**CITY OF NAPOLEON  
BUILDING CONSTRUCTION PERMIT  
(1, 2 or 3 Family Dwelling)**

Zoning "A" Intended use of Building: Constructing to the rear of the  
of the existing dwelling, 11'x13' wood frame open screened patio,  
(No slab)

DATE	June 13, 1975	JOB NO.	Permit No. 294-75
PROJECT	11 X 13' Wood Frame Patio		
LOCATION	14 Park Ct.		
CONTRACTOR	King	OWNER	Conrad
WEATHER		TEMP.	° at AM ° at PM
PRESENT AT SITE	CITY OF NAPOLEON ENGINEERING DEPT. PLAN APPROVAL BY <u>[Signature]</u> DATE: <u>6/13/75</u>

TO Norman King  
840 Strong St.  
Napoleon, Ohio, 43545  
Addendum To Plans Approval

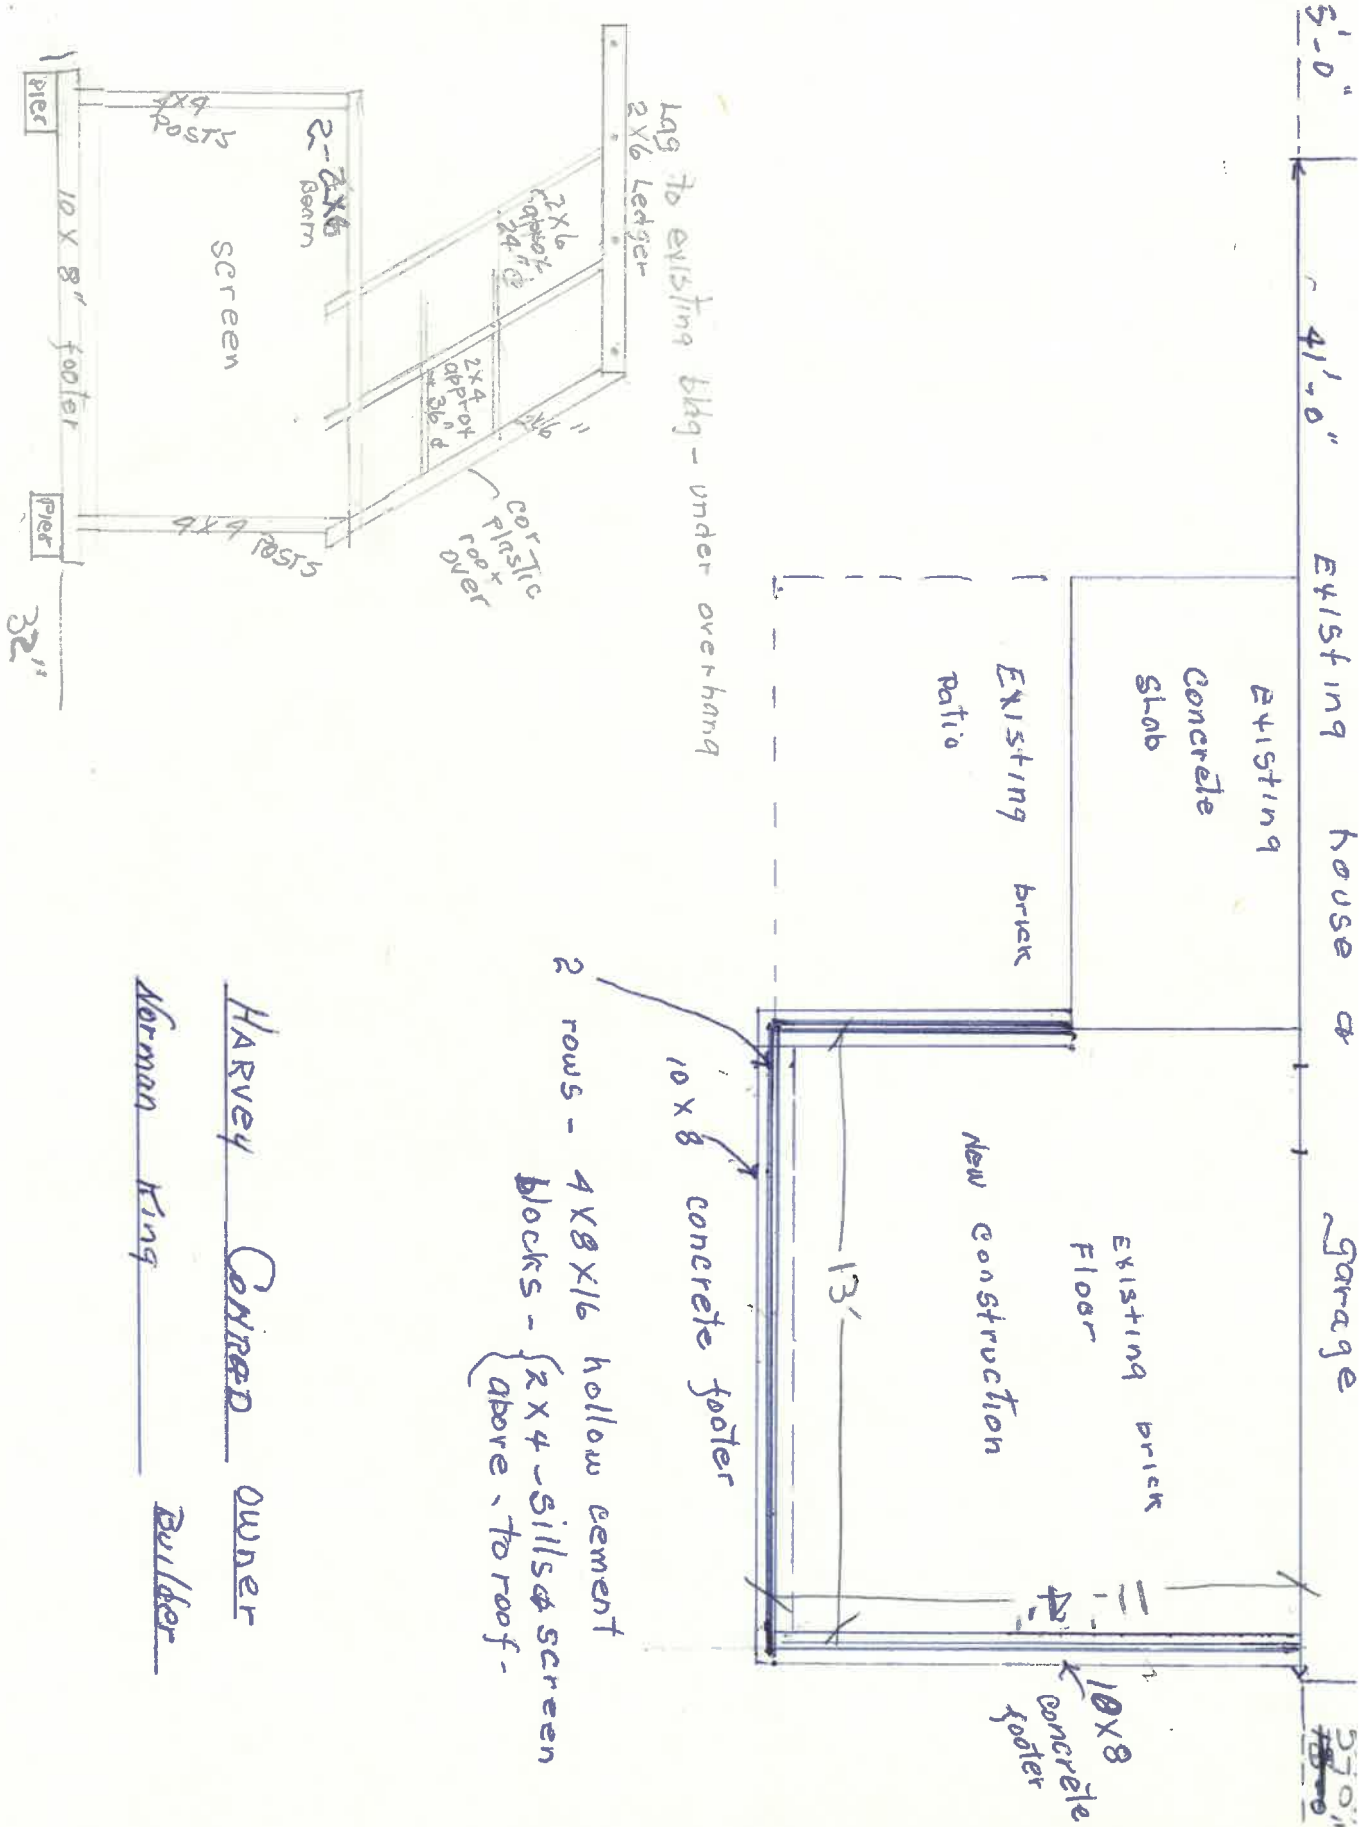
- > During plan review and must conform to the City's adopted building codes:
- 1) Maximum allowable spans for headers supporting the roof system would be 2-2"x6" with a maximum span of 6'. Sec. R-402, Table No. 4-B.
  - 2) Must provide Min. size of 8"x8" concrete piers below each supporting column. Also must be min. of 32" below finished grade. Sec. R-304, Figure No. A-3.
  - 3) Provide means of securing 4"x4" post to concrete piers.
  - 4) Because of span and 24" g/c of roof rafters must use nothing less than yellow pine lumber. Sec. R-704, Table No. 7-M.
  - 5) Because piers were poured and back filled  
Note: ~~rafters or piers installed prior to the permit was disturbed~~, you must expose all piers for inspection by me.
